**NM1 - \_\_\_\_\_ 50 \_\_\_\_\_**

**BORING  
PLAN(S)**

**RE: Boring Plan – Proposed Work Plan  
Commercial Surface Waste Management Facility  
Crowe Blanco, LLC – Blanco Landfarm  
Facility Location: W/2 and SW/4 SE/4 of Section 16, Township 29 North, Range 9 West NMPM  
San Juan County, New Mexico.**

RE: Proposed Work Plan  
Additional Monitor Wells Installation  
Crowe Blanco Properties, LLC – Operated by IEI  
Blanco, New Mexico

Approximate Not to Scale	<b>SITE PLAN</b> Monitor Well Locations (approximate)	<b>PROJECT</b> Crowe Blanco Properties, LLC Operated by IEI Blanco, New Mexico	
	GEOMAT Project No. 102-1162

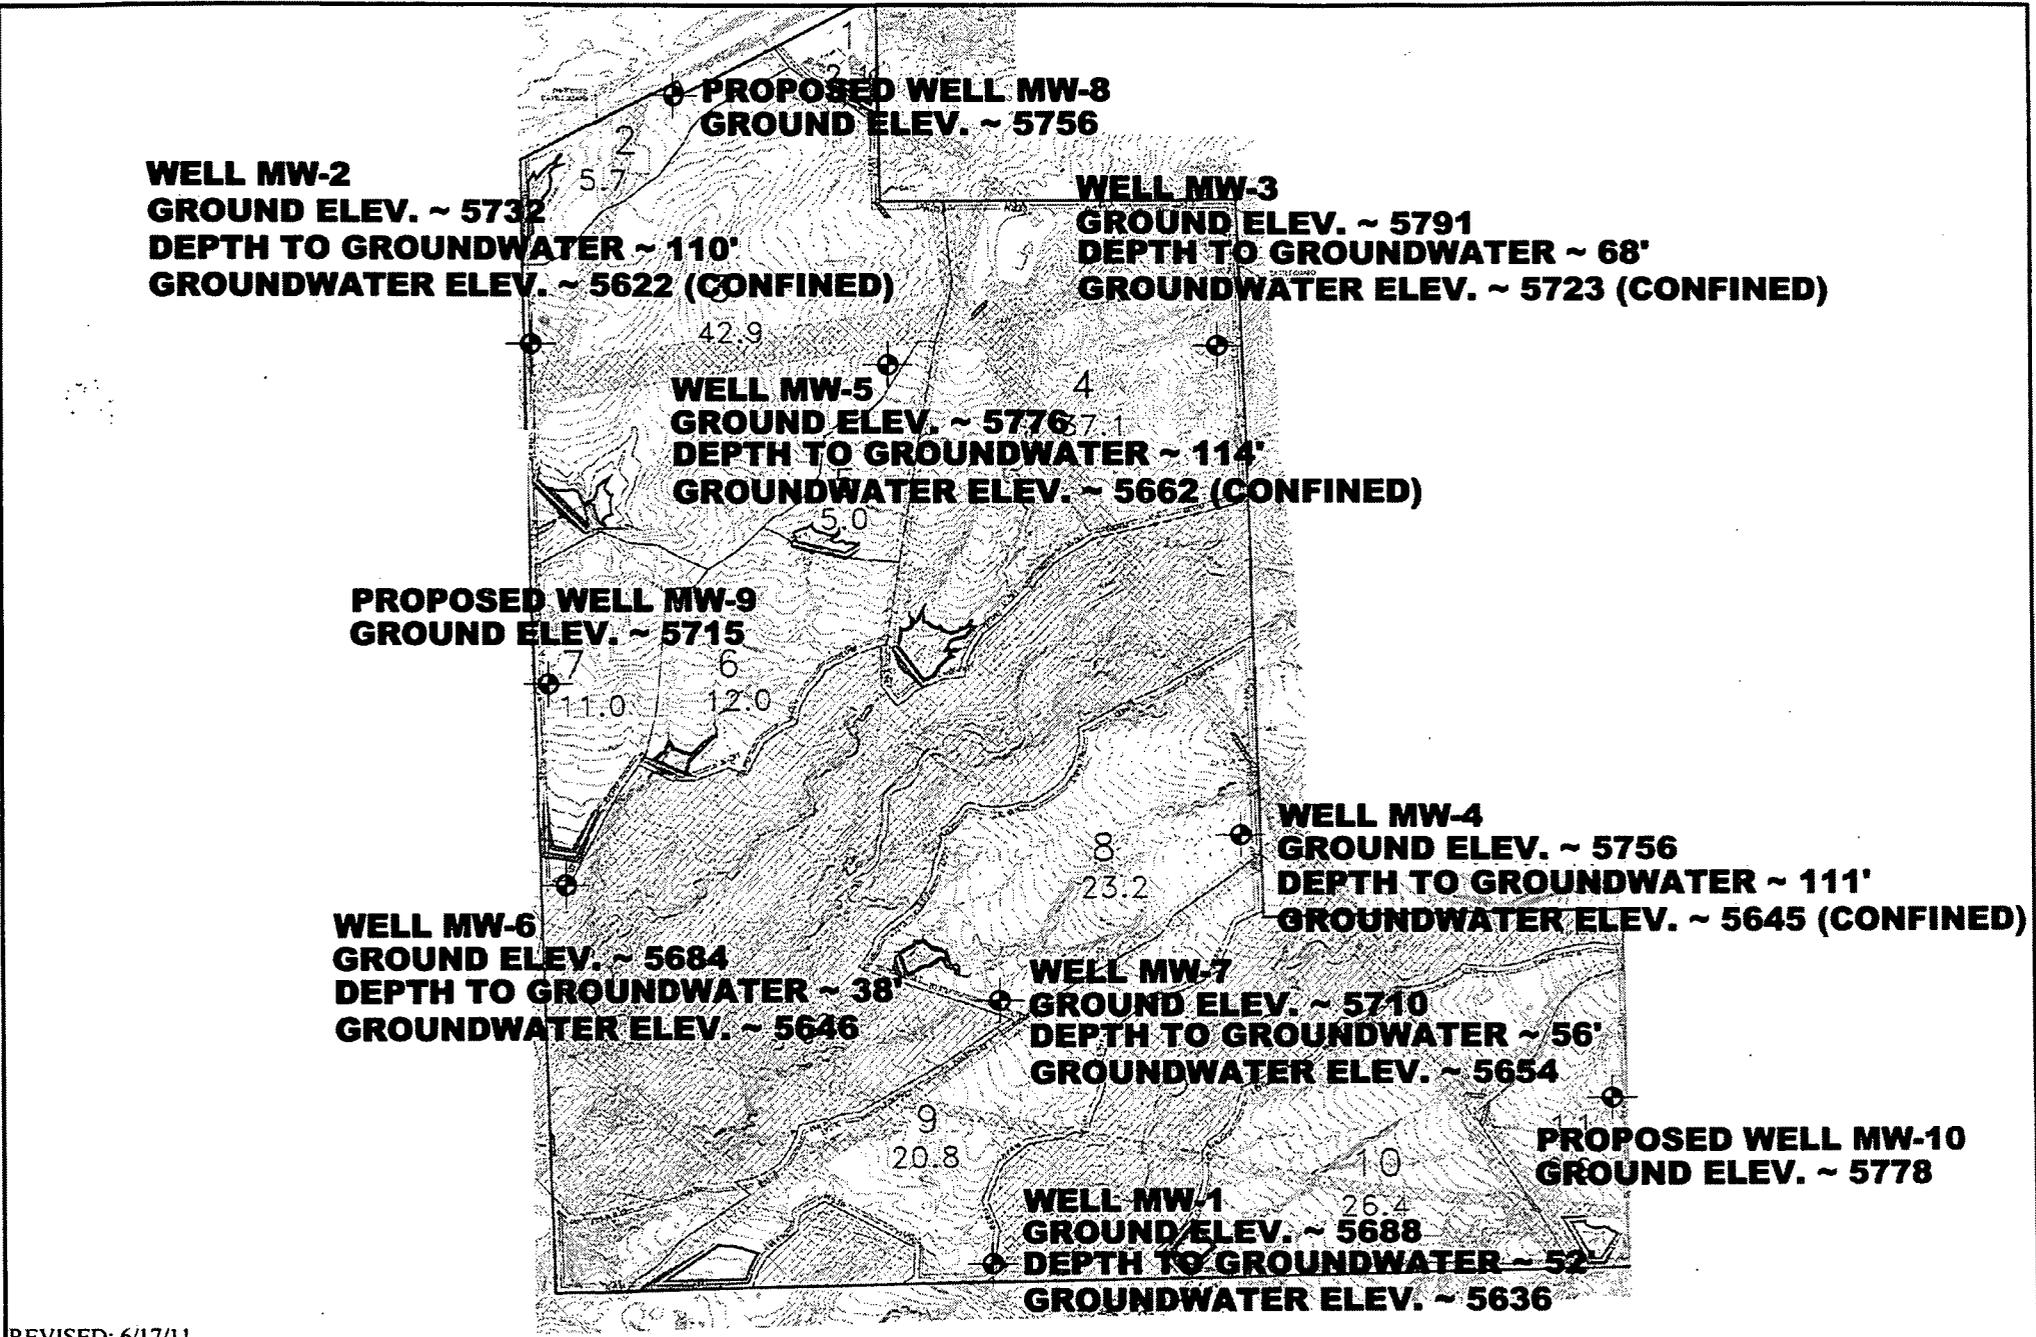
The Oil Conservation Division (OCD) has received Crowe Blanco, LLC's boring-plan proposal, dated June 17, 2011, to further investigate and characterize the uppermost aquifer and subsurface geology for a proposed commercial surface waste facility permit (Blanco Landfarm) located in the W/2 and SW/4, SE/4 of Section 16, Township 29 North, Range 9 West NMPM, San Juan County, New Mexico. The OCD has reviewed the proposal and determined that the proposal is adequate to proceed with the additional site investigation.

The OCD agrees that the proposed three (3) additional boring/monitoring well locations appear adequate. However, if the hydrogeologic conditions cannot be determined, additional borings or monitoring wells may be needed. It should be understood that if a monitoring well is constructed, it shall be bailed until fully developed.

**SITE PLAN**

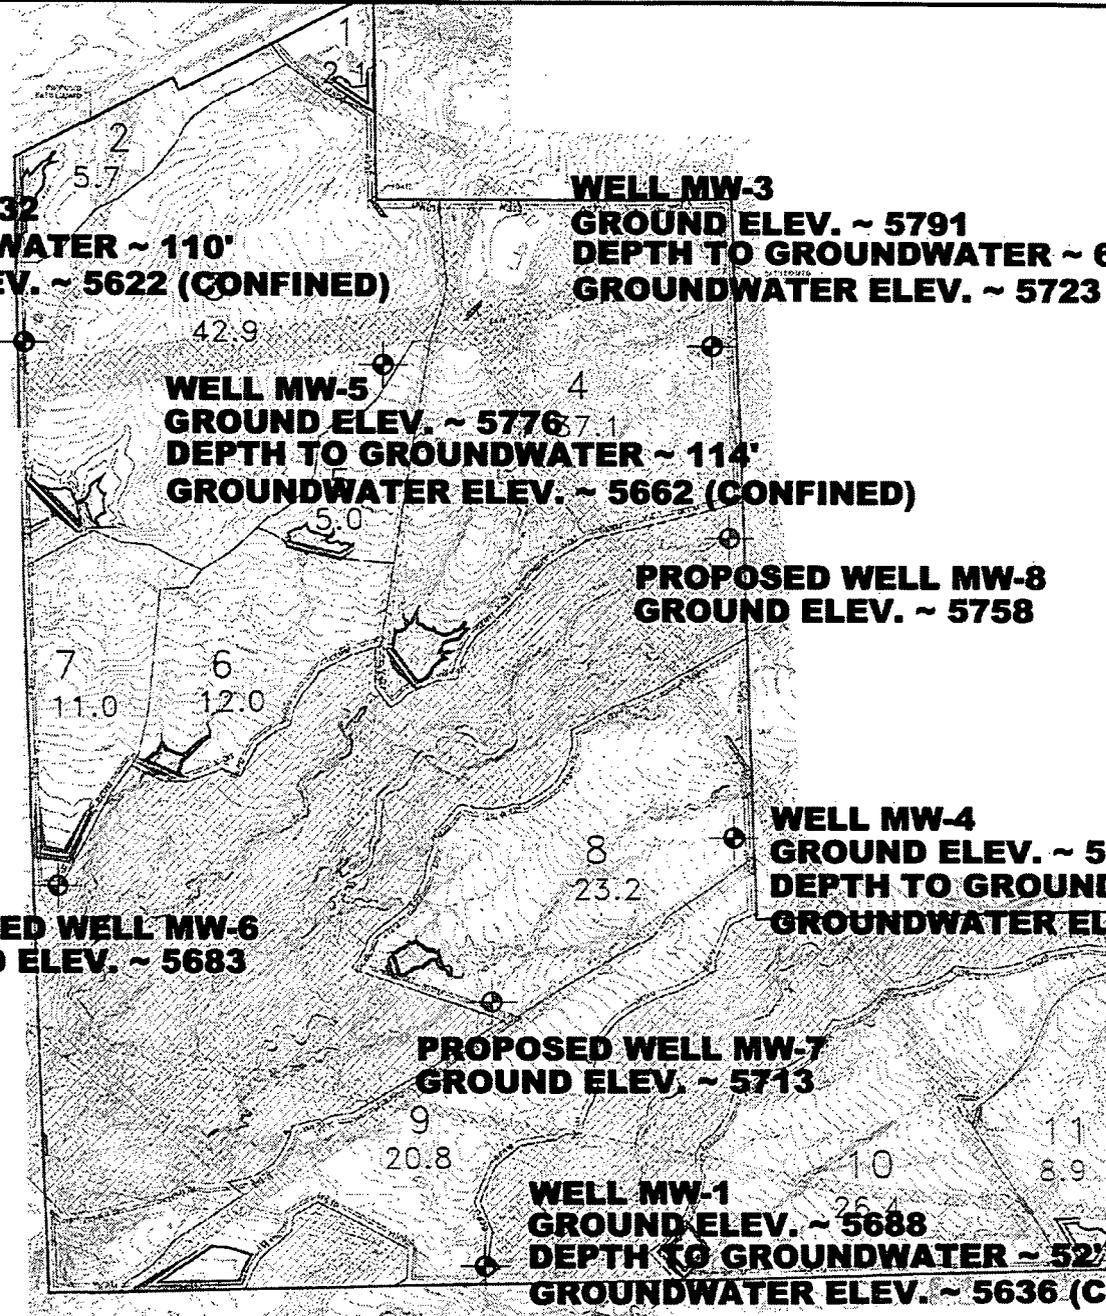
The total depth of each proposed well has been changed from 110 feet to 120 feet. The proposed location of MW-7 was moved slightly to the southeast on the Site Plan, and the ground surface elevation changed accordingly.

The Oil Conservation Division (OCD) has reviewed the attached document and determined that the boring plan proposal is adequate to proceed with the site investigation. It should be understood that if a monitoring well is constructed, it shall be bailed until fully developed. Please provide directions and maps to the proposed site and a confirmed start time and date for the drilling activities. The OCD appreciates the efforts of Cheney-Walters-Echols, Inc. and GEOMAT in considering OCD's recommendations to the proposal. If you have any questions regarding this matter, please do not hesitate to contact me.

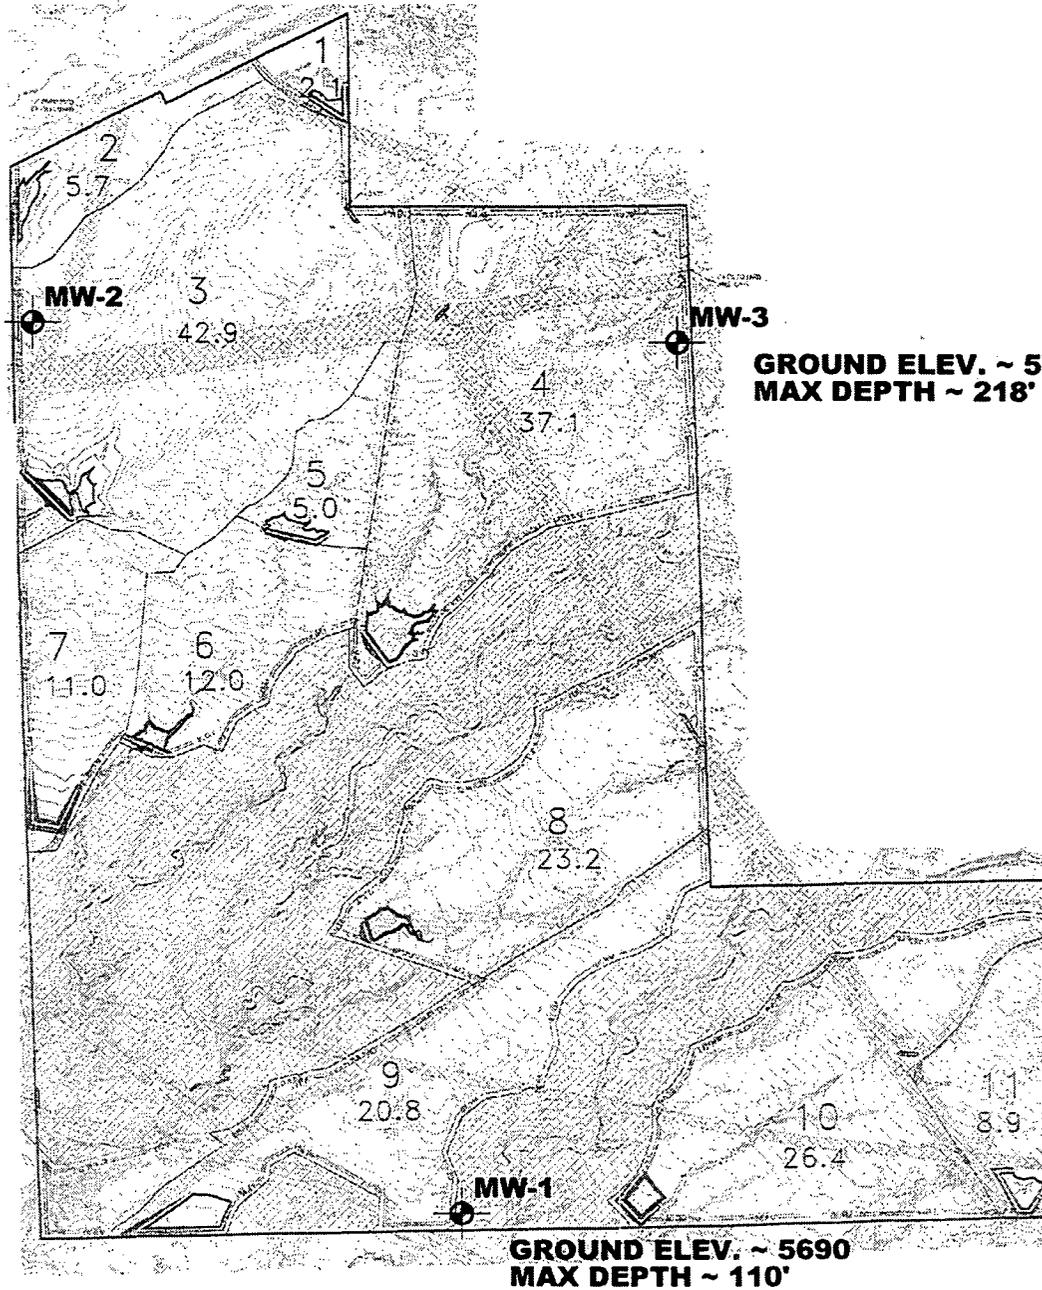
The map forwarded from Mr. Lewis Hare of your office only provided the surface/top of concrete pad elevation (I'm unsure which one it represents - please clarify) and the top of casing (TOC) elevation for each monitoring well installed at the proposed landfarm site. In order for OCD to provide comment, we will need the lithologic log, the depth to ground water, and the ground water elevation for each monitoring well. Without this information, the OCD is unable to comment or consider the proposed locations for the additional monitoring wells/borings. Please provide the necessary information.

SITE PLAN  
Monitor Well Locations (approximate)  
GEOMAT Project No. 102-1162

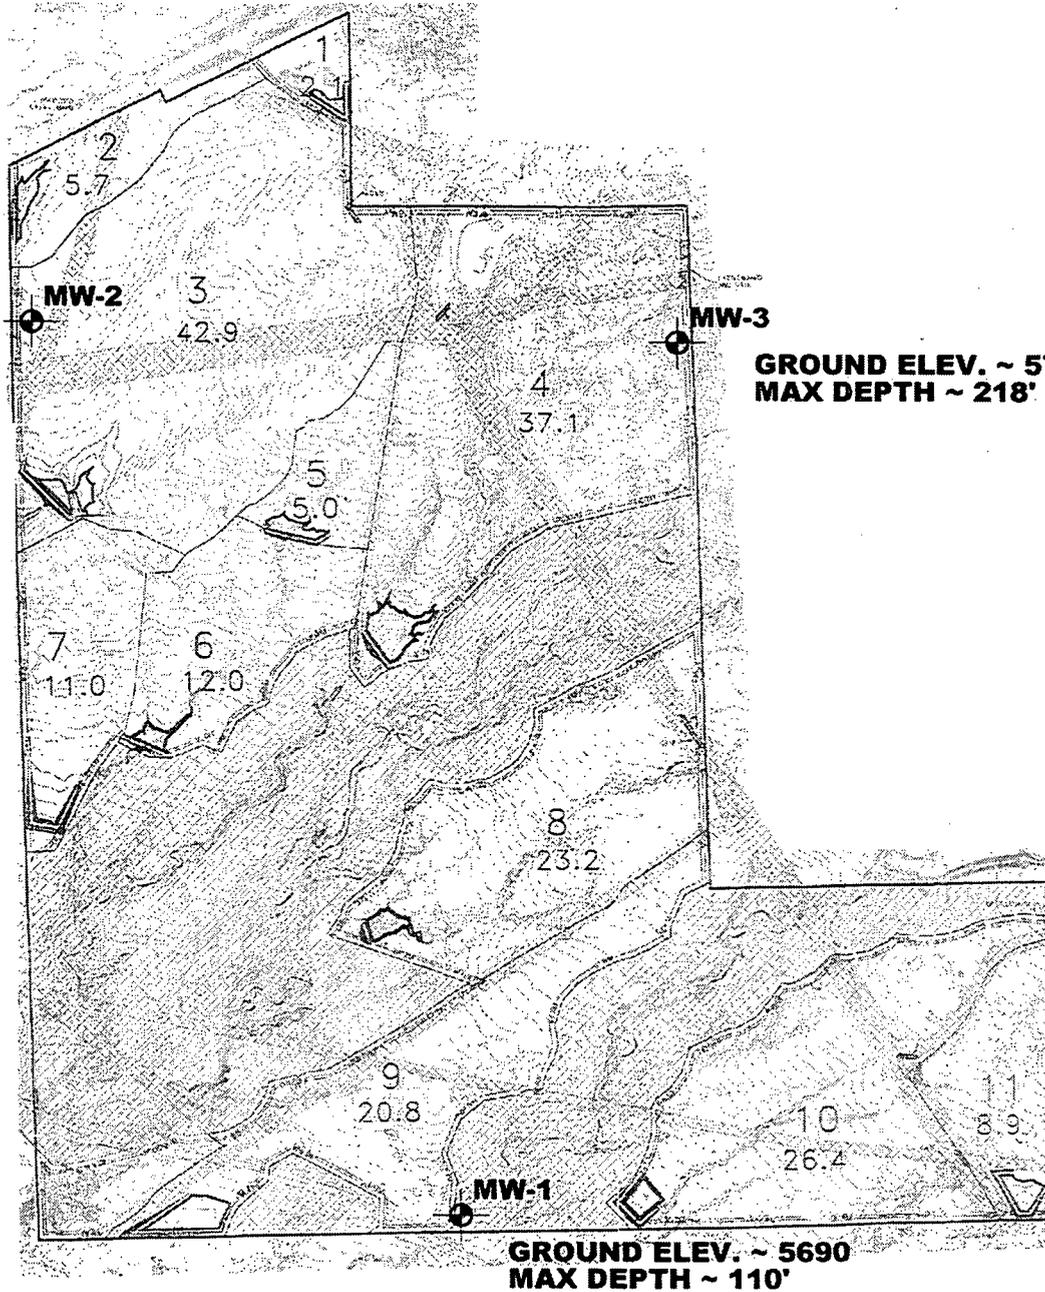
- The plan depths for MW-2 and MW-3 were changed from 144' and 208' to 154' and 218', respectively. This was so that all three wells would be drilled to the same elevation of 5580.
- It was made clearer in the plan that each moist zone encountered would be evaluated to determine if it could be a water-producing zone.
- It was made clearer in the plan that continuous core samples of the subsurface materials will be obtained.
- The driller's plan was changed to say that foam injection would be used on a limited basis and that the wells would be developed by bailing to remove sediment.

The Oil Conservation Division (OCD) has received Crowe Blanco, LLC's revised boring plan proposal, dated November 1, 2010, to investigate and characterize the uppermost aquifer and subsurface geology for a proposed commercial surface waste facility permit (Blanco Landfarm) located in the W/2 and SW/4, SE/4 of Section 16, Township 29 North, Range 9 West NMPM, San Juan County, New Mexico. The OCD has reviewed the proposal and determined that the proposal is adequate to proceed with the site investigation.

The OCD agrees that the proposed the boring/monitoring well locations appear adequate for the proposed landfarm. However, if the hydrogeologic conditions cannot be determined, additional borings or monitoring wells may be needed. It should be understood that if a monitoring well is constructed, it shall be bailed until fully developed. Also, please provide OCD with directions and maps to the proposed site and a confirmed start time and date for the drilling activities.
